## NICK HELME BOTANICAL SURVEYS

### **Update to Specialist Botanical Assessment – CTFS**

This report was requested subsequent to my most recent iteration of the botanical assessment of the Cape Town Film Studio development plans, dated 21 June 2016. The Terms of Reference for the current report were to:

**Plate 1:** View of seasonal wetland (foreground) in the outdoor studio area, with permanent wetland in the background.

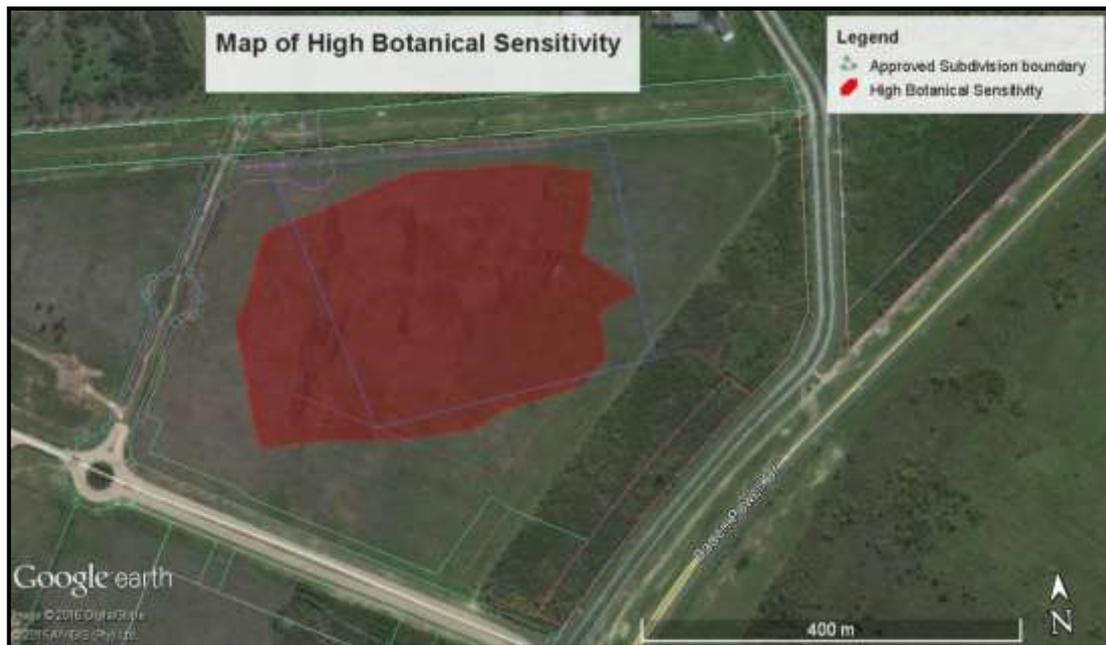
Three primary habitats occur within the area – seasonal wetlands, permanent wetlands, and well drained sands. The permanent wetlands are characterised by *Typha capensis* (bulrush), whilst the seasonal wetlands have a number of micro-habitats on sandy clay soils (see Plate 1). These plant communities have suffered in the drought and indeed many of the perennial species in these habitats now

There is effectively no mitigation that can be undertaken for the wetland vegetation, other than removal of all woody alien vegetation on site, which should thus be done. Permanent removal of all livestock from the study area would also have a positive effect on the natural vegetation, and this will presumably happen as soon as the area is fenced off, which will presumably need to happen once it is an outdoor studio area.

**Plate 2:** View of dune area in the outdoor studio area, showing almost total lack of indigenous shrubs.

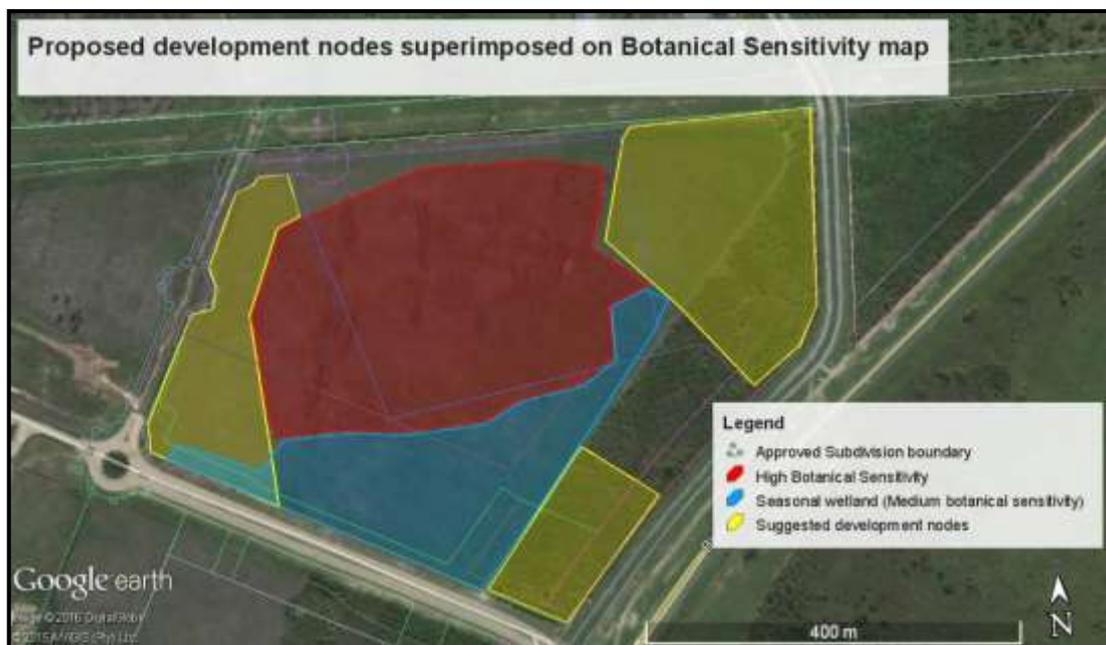
The dune areas, on well drained sands, have been heavily impacted by previously dense stands of alien invasive vegetation like rooikans and Port Jackson, but these two woody species have been harvested for firewood, and alien density is thus much lower now than ten years ago. However, very little indigenous vegetation has re-established, due mainly to heavy grazing by roaming livestock, and the few shrubby species include *Searsia leavigata*, *S. lucida*, *Euclea racemosa* and *Pterocelastrus tricuspidatus*, but indigenous perennials like this cover only about 5% of the area. Two species of indigenous bulb are however much more common, and these are *Haemanthus coccineus* (paintbrush; Plate 3) and *Zantedeschia aethiopica* (arum lily) – both of which are toxic to livestock. It is estimated that about 2000 plants of the former are still present on these dunes, and about 1000 plants of the latter.

If the dunes are to be fully or partly flattened it is strongly recommended that all bulbs on site (notably *Haemanthus coccineus* (paintbrush) and *Zantedeschia aethiopica* (arum lily)) should be rescued and translocated prior to earthmoving. However, there is no suitable receiving habitat of this type on site where they will be safe in perpetuity, and thus it is suggested that they be translocated to Driftsands Nature Reserve (managed by CapeNature), which supports similar habitat (Cape Flats Dune Strandveld) that is in need of rehabilitation. This translocation should be undertaken just after the leaves start to shrivel in early summer (probably October), as the plants are going dormant for the dry season, but when they are still visible above ground. Translocation should happen immediately, avoiding the need for lengthy storage in a nursery.
